27 July 2021

**89 JOHN WHITEWAY DRIVE, GOSFORD (SSD-10321)
REQUEST FOR ADDITIONAL INFORMATION**

Figure 1 Site Tree Canopy Coverage Plan

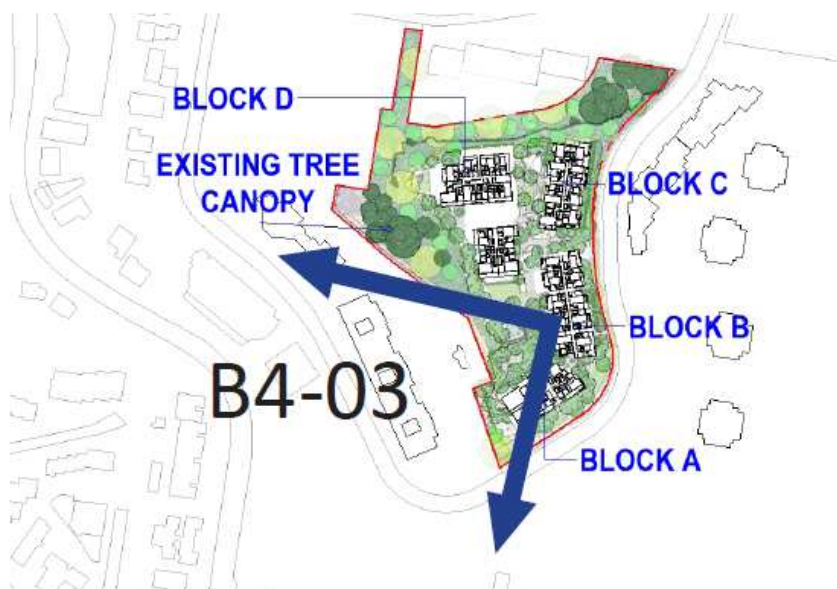
The Department has requested information to clarify if the tree canopy would interrupt water views. While a tree survey was completed to inform the building massing as required by the Planning Principles, the survey is 3D and not capable of providing in 2 dimension (i.e by PDF). The survey has been provided to the Department in its original .dxf file previously. Accordingly, the Department should refer to the Landscape Plan (Drawing 10-19.16, Site Tree Canopy Coverage Plan, dated 27.05.2021) that identifies the tree canopy, as shown on the reference plans submitted with the View Model (i.e the Dark Green Circles) see **Figure 1**.

This query has resulted in Unit D1-3 from being excluded from the view analysis to be conservative. It is clear from the model views that 47 units have water views and the Department should be satisfied that the existing Tree Canopy will not interrupt these.

Figure 3 Basement Level (Garage Security Doors)

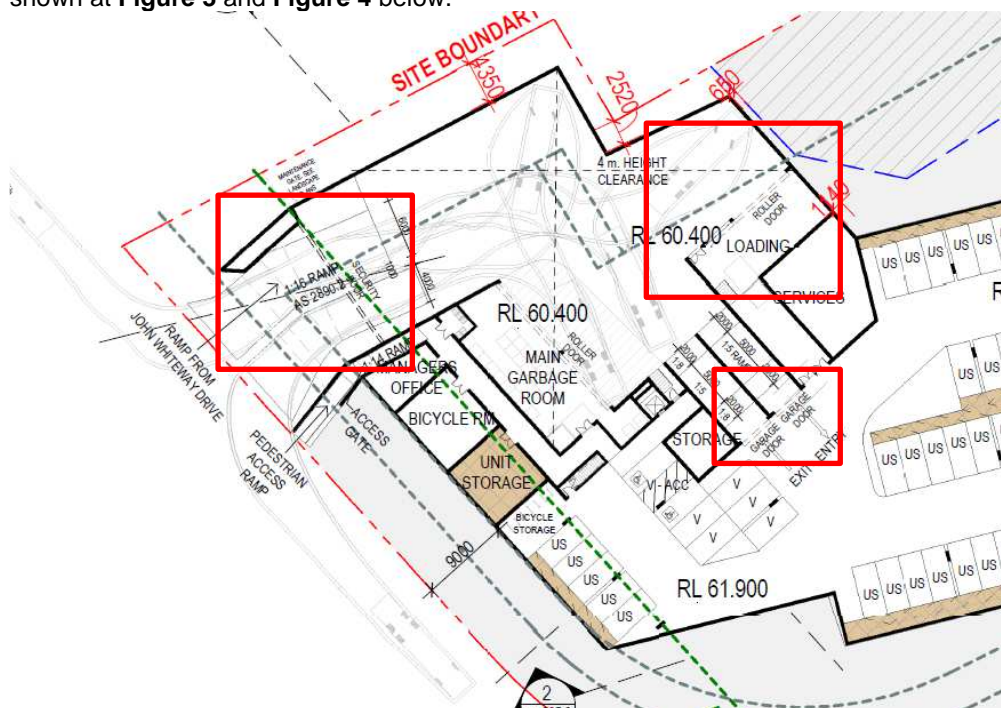
<p>Basement Entry</p> <p>Please indicate the location of the security door to the basement entry on the architectural plans.</p>	<p>See Section 1.4 below and Appendix E.</p>
<p>Tree Canopy Survey</p> <p>As requested previously, please provide a copy of the tree canopy survey to inform the Departments assessment. It is noted that a copy of the survey was provided by Ethos with the RtS, however due to the file type it could not be opened. Please provide the survey in a PDF format.</p>	<p>The tree canopy survey is cloud based information and not capable of being printed in 2 dimension or PDF format. The survey was a request of the Department to inform the built form massing, and the Planning Principles for the site.</p>
<p>BASIX</p> <p>The BASIX certificate provided with the amended DA states ‘this is not a valid certificate’. Please provide a valid certificate to support the amended DA or any future amended plans.</p>	<p>See Appendix F.</p>

Architectural Plans DA002.1 and DA002.2 (**Appendix E**) have been amended to better identify garage doors, as shown at **Figure 3** and **Figure 4** below.
